Proposal for amendments to ECE/TRANS/WP.29/GRSG/2015/2 UN Regulation No. 46 (Devices for indirect vision)

The text reproduced below has been prepared by the informal group IGCMS-II for amending its proposal ECE/TRANS/WP.29/GRSG/2015/2 to incorporate amendments agreed upon at its 8th meeting. The modifications to the current text of ECE/TRANS/WP.29/GRSG/2015/2 are marked in **underlined** for new or ~~double strikethrough~~ for deleted characters.

"6.2.2.3.3.2. Luminance and contrast rendering

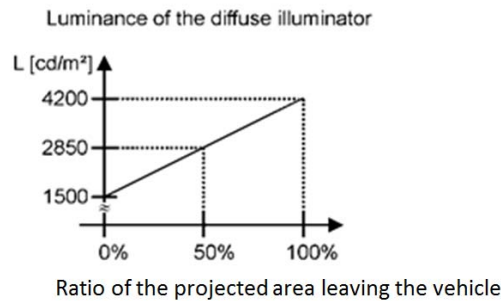
- (a) The minimum luminance contrast at the monitor (including any screen protector) reproducing a high contrast pattern shall be:
 - (i) for direct sunlight condition: 2:1
 - (ii) for day condition with diffuse ambient light: 3:1
 - (iii) for sunset condition: 2:1
 - (iv) for night condition: 10:1 except in case of Mirror and CMS dual function system of class I: 5:1
- (b) unchanged
- (c) The background luminance of the monitor shall be limited under the night condition. ~~Depending on the installation of the monitor inside the vehicle this will reduce disruptive reflections on the windscreen or other window panes.~~ The maximum background luminance under the night condition shall be less than 2.0 cd/m²,
- (d) unchanged."
